From: Rebecca Tier <rebecca@manorwood.co.uk>
Sent: 08 July 2026 09:34:26 UTC+01:00
To: "Katherine Williams" <katherine.williams@midsussex.gov.uk>
Cc: "Ben Kirk" <ben@manorwood.co.uk>
Subject: DM/25/3028 - West House Farm Henfield Road Albourne

Our client's flood and drainage consultant, Motion, has provided the following the responses in red below and the additional information attached as requested by the Council's Drainage Team.

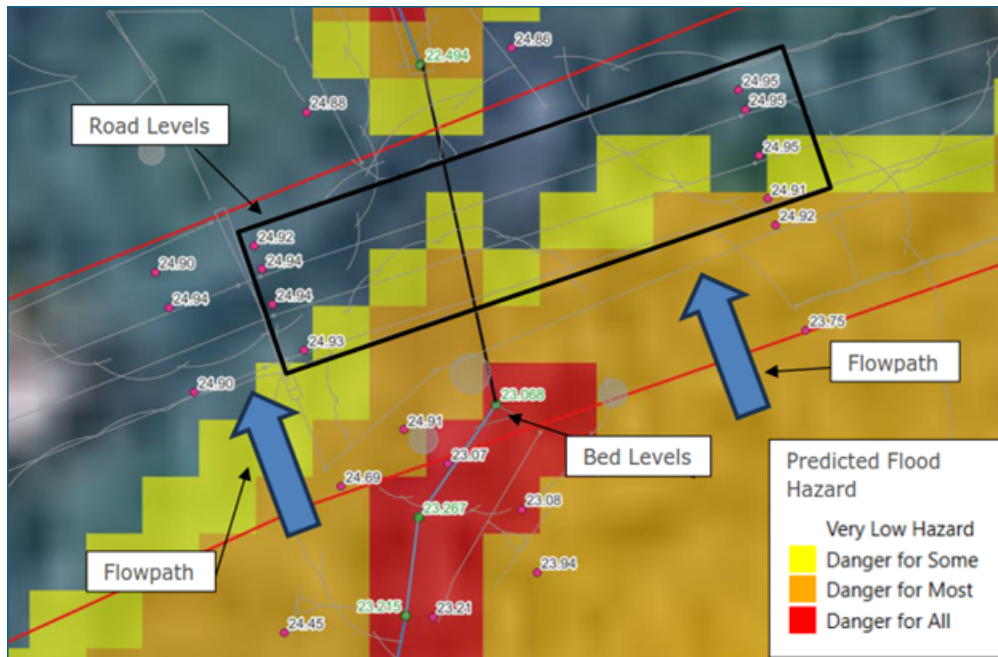
The submitted hydraulic modelling provides an assessment of flood risk associated with the culverted watercourse crossing beneath the access road. Whilst this work is welcomed, the modelling indicates flood depths of up to approximately 0.37m and identifies areas of elevated flood hazard in the vicinity of the culvert crossing.

The conclusion that the identified hazards are overstated appears to rely upon professional judgement regarding potential interpolation errors within the model. However, no revised modelling has been submitted to demonstrate the extent to which the results would change following correction of these issues.

As such, it has not been conclusively demonstrated that safe access and egress can be maintained during the relevant design flood events.

The technical note prepared by Motion includes the results of hydraulic modelling undertaken for the culverted watercourse, with Ardent's modelling indicating that flooding would only affect a short section of the access road (approximately 25 m) during an extreme event, with shallow depths and very low risk elsewhere. Surveyed levels along the access route range from 24.91 m to 24.95 m AOD, while the adjacent watercourse bed level is 23.068 m AOD. See figure below.
